## **8.8. Planning Proposal 3/20 - 20-22 Atchison Street, St Leonards**

To present to Council the assessment of a Planning Proposal which seeks to amend North Sydney Local Environmental Plan 2013 (NSLEP 2013) as it relates to land at 20-22 Atchison Street, St Leonards.

### **Amended Planning Proposal (subject of this report)**

**FIGURE 14: Area Schedule (p.82 Urban Design Report)**

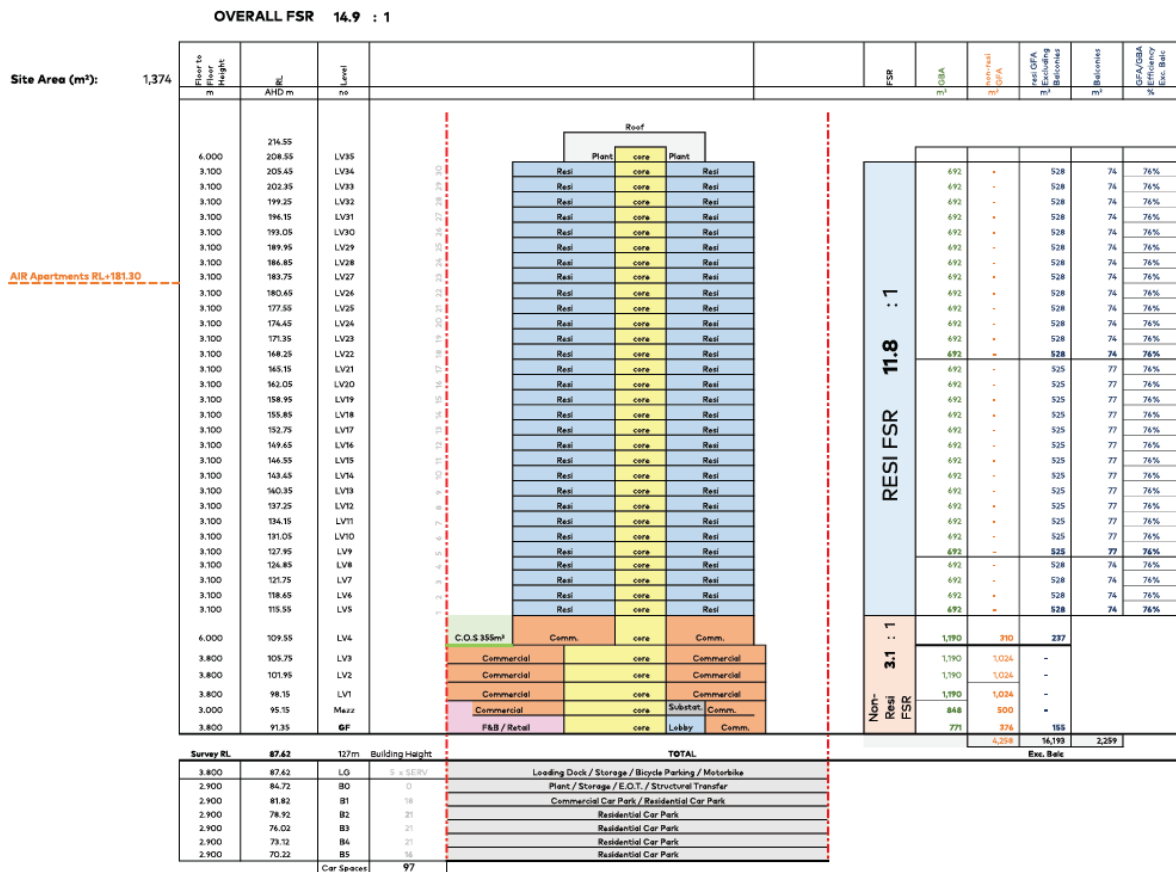
- the podium height of 18.2m is excessive for 4 storeys and could be reduced;
- the proposed 6.8m floor-to-floor height at the ground floor appears excessive. It is considered that the mezzanine level provided within the ground floor should be included as a storey and as commercial floor space calculations;
- the 6m floor-to-floor height on level 4 (as referenced in Figure 14) appears excessive and could be reduced;
- the 6m height of the roof plant appears excessive.

On this basis, the proposed building height of 127m appears excessive for the number of storeys, even taking into account topography, and could potentially result in a building greater than 35 storeys. The concept proposal clearly reflects 36 storeys (5 storey podium and 31 storey tower) with an allowance sought for an additional 3.8m over and above the roof plant level. The proposed building height of 127m also increases overshadowing impacts to the public domain, contrary to the provisions of the 2036 Plan (refer to section 7.5.1 of this report).

**FIGURE 15: Overshadowing Analysis – Mitchell Street Plaza**  
(p.55 Urban Design Report)

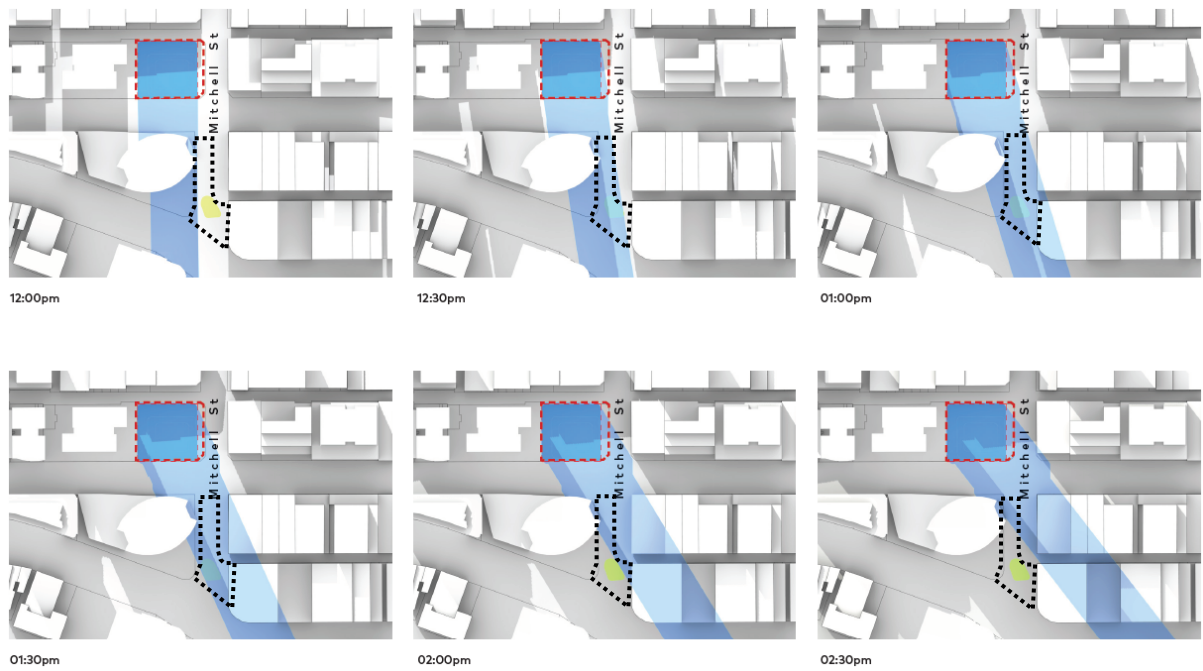
Despite an increase in solar access to Mitchell Street during the 11.30am to 12 noon period, as illustrated in Figure 15, the proposed podium and tower elements will cast additional shadows over Mitchell Street between 12pm-2.30pm. It is acknowledged, however, that even a compliant scheme would create additional overshadowing impacts to Mitchell Street Plaza. Notwithstanding, the concept proposal's impacts should be compared to a building form which is compliant with the relevant, height, FSR and setback controls identified under the 2036 Plan. As illustrated in Figure 16, the proposed tower element will cast additional shadows over Hume Street Park at 2.50pm for 10 minutes, affecting approximately 3.6% of the park. The justifications made in the Planning Proposal, that the impacted area is a portion of a hard surface driveway area and not within useable open space and will be offset by new public domain space along Mitchell Street, is considered immaterial in this context.

**FIGURE 16: Overshadowing Analysis – Hume Street Park**  
**(p.56 Urban Design Report)**

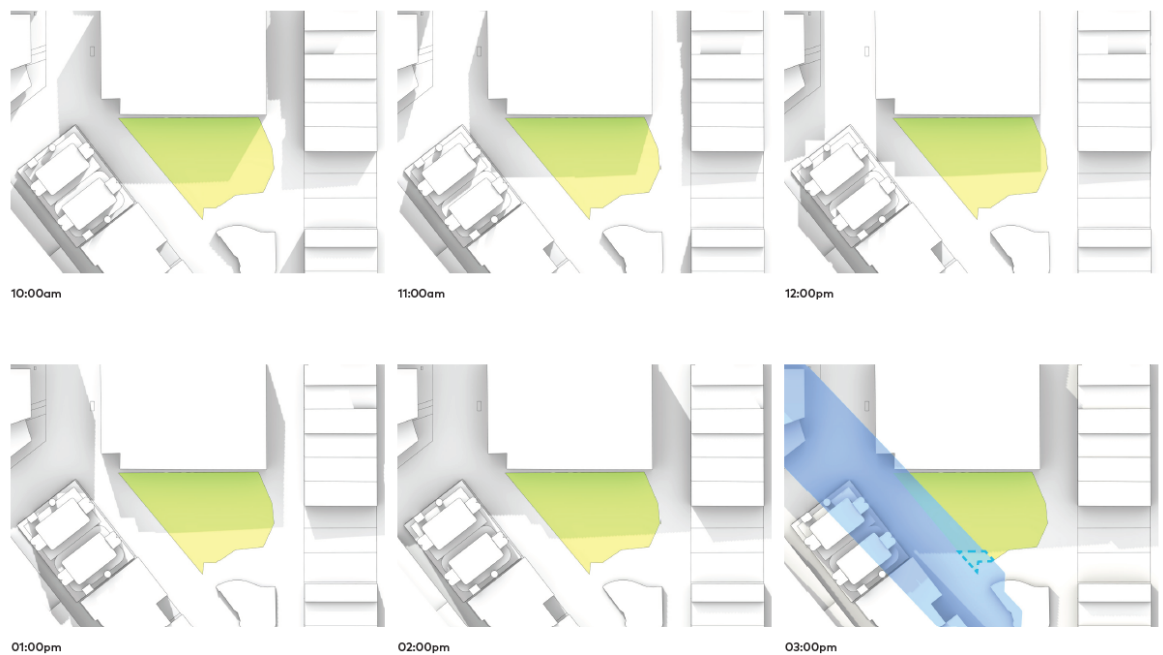
Hume Street Park is identified to be upgraded under the 2036 Plan and accompanying SIC Plan in recognition of the critical need for additional, high-quality public open space within the St Leonards/Crows Nest precinct. Solar access to this space is deemed critical given the general lack of access to usable open green space in the Precinct. This is reinforced by Council's long-term plans for the park. A Planning Proposal seeking a non-compliant Height and FSR control and directly facilitates increased overshadowing of key public open space is contrary to sound planning principles and is unable to be supported.

*Figure 17: Indicative concept scheme – Podium Elevation (Atchison Street)  
(p.65 Urban Design Report)*

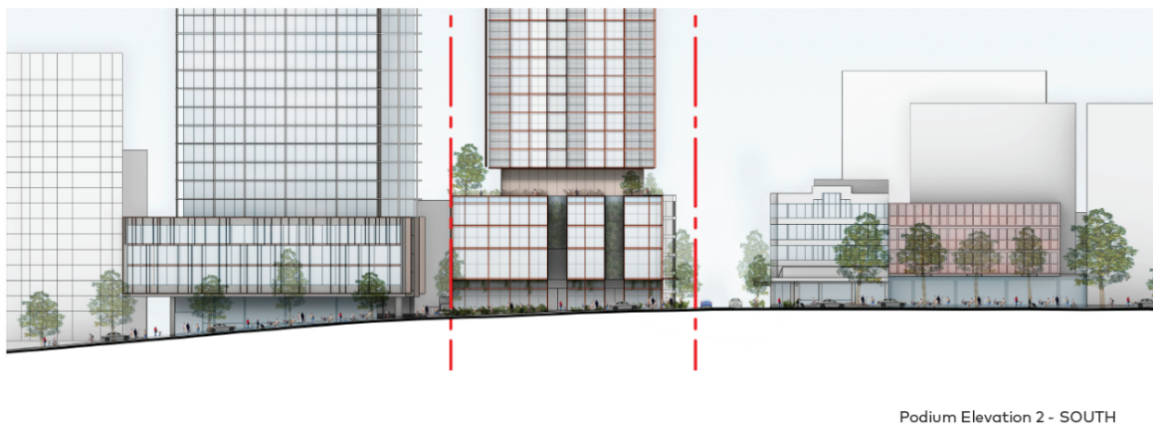
The proposal complies with the 3m reverse setback at the ground level to Atchison Street, however, the overall scale of the proposed podium is excessive and inconsistent with the emerging street character. The proposed street wall (podium) height of 18.2m is excessive and should be reduced to better relate to the 4-storey podium of the adjacent development at 6-16 Atchison Street (refer to Figure 17). The proposed 2m setback above the podium is inadequate and results in a bulky and visually dominant built form.

Council has consistently required new development along Atchison Street to have its levels above the podium setback 3m from the boundary. This is in accordance with the setback requirements under NSDCP 2013 Character Statement, which were informed by Council's *St Leonards/ Crows Nest Planning Study – Precincts 2 & 3 (2015)*. They seek to ensure built form outcomes of an appropriate scale that maximise solar access and establish Atchison Street as the 'civic' main street of St Leonards. A 3m setback above a 4-storey podium would provide a more appropriate contextual response to Atchison Street consistent with the objectives of the 2036 Plan.
